STATE OF WASHINGTON
DEPARTMENT OF ECOLOGY

RE: Ecology comments on draft Inundated Lands Initial Investigation Work Plan Addendum:

- **Site Name:** BNSF Track Switching Facility aka Wishram Railyard
- **Site Address:** 500 Main St., Wishram, Klickitat County
- **Facility Site ID No.:** 1625461
- **Cleanup Site ID No.:** 230
- **Agreed Order:** DE 12897

Location of Outfalls

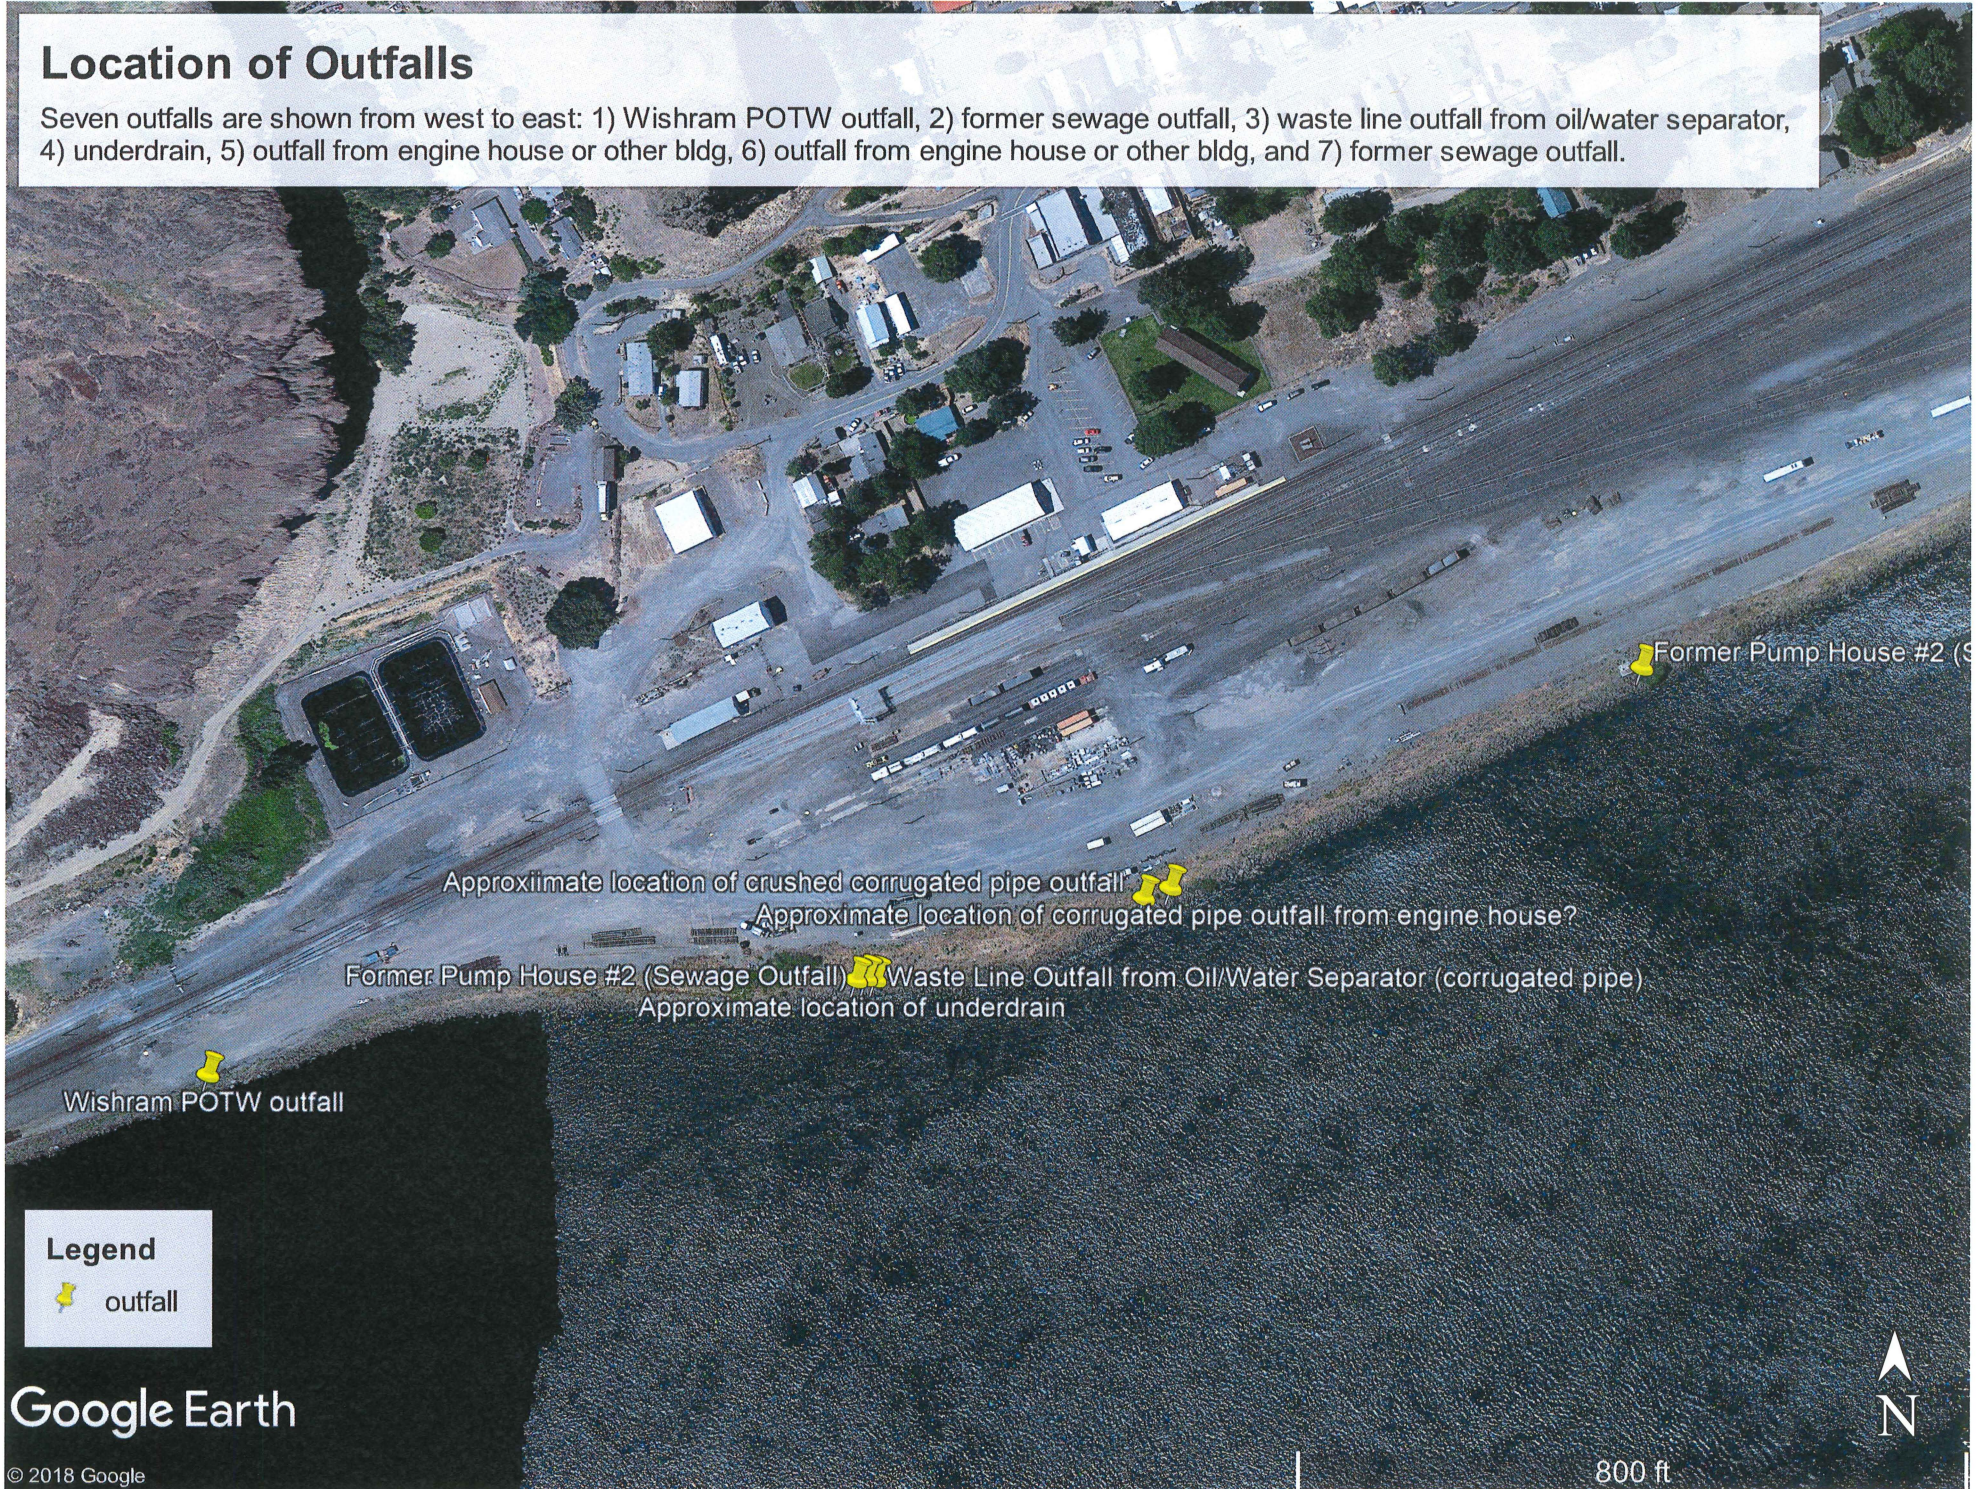
Please incorporate additional surface sediment sampling locations at the seven outfall locations shown in the attached kmz file, either during the current investigation phase or in a subsequent investigation phase.

These areas of potential concern (AOPCs) include two municipal sewage outfalls, the current publicly owned treatment works (POTW) outfall, the stormwater underdrain, and former oil drain lines or other waste lines. The investigation should focus on the point of discharge, along the channel historically cut into the bank, and in any depositional area at the bottom of the historical bank.
